# Access Compliance Report

## Public Rights-of-Way

### (Curb Ramps)

Intersection ID: 3033	Main Street: DEARMON_RD	Cross Street: BENFIELD_RD	Location:	S
ADA ID: 74D7FE014623	Ramp Type: Perp	Initial Pass/Fail: Fail	Overall Compliance: No	Severity Score: 25
Codes/Mitigation Info/Possible Solution		Field Measurements/Component Compliance

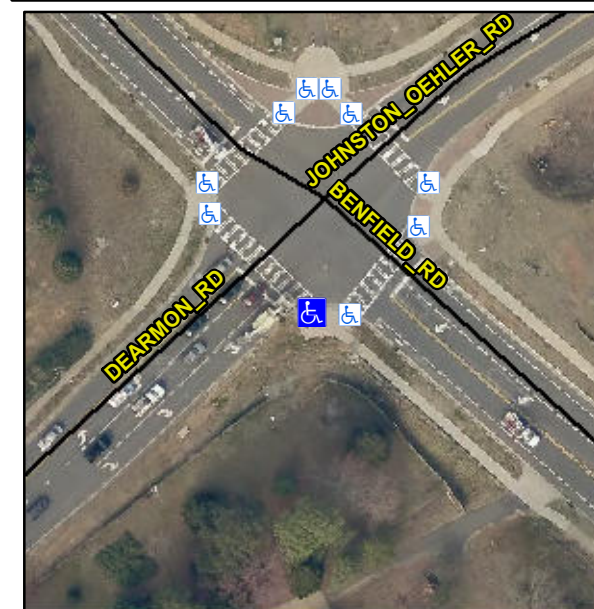
**R304.2.2**

Compliance	Description	Data	Compliance	Description	Data
N/A	Ramp Length (in)	94.0	No	Ramp Slope (%)	12.3
Yes	Ramp Width (in)	74.0	Yes	Ramp XSlope (%)	0.2
N/A	Flare Type LT	N/A	N/A	Flare Type RT	N/A
N/A	Flare Slope LT (%)	N/A	N/A	Flare Slope RT (%)	N/A
N/A	Flare Traversable LT?	N/A	N/A	Flare Traversable RT?	N/A
N/A	Landing Length (in)	N/A	N/A	DWS Provided?	N/A
N/A	Landing Width (in)	N/A	N/A	DWS Contrast?	N/A
N/A	Landing Slope (%)	N/A	N/A	DWS Length (in)	N/A
N/A	Landing X Slope (%)	N/A	N/A	DWS Full Width?	N/A
N/A	Landing Curb? (Y/N)	N/A	N/A	DWS Offset (in)	N/A
N/A	Shared Landing?	N/A			
N/A	Gutter Ponding?	N/A	N/A	Gutter Slope (%)	N/A
N/A	Gutter Lip Ht (in)	N/A	N/A	Gutter X Slope (%)	N/A
N/A	Painted X Walk1?	Yes	N/A	Painted X Walk2?	N/A
	X Walk 1 Direction	To NW		X Walk 2 Direction	N/A
N/A	X Walk 1 Width (in)	120.0	N/A	X Walk 2 Width (in)	N/A
	X Walk 1 Slope (%)	3.0		X Walk 2 Slope (%)	N/A
	X Walk 1 X Slope (%)	2.6		X Walk 2 X Slope (%)	N/A

**Remove & Replace Entire Ramp.**
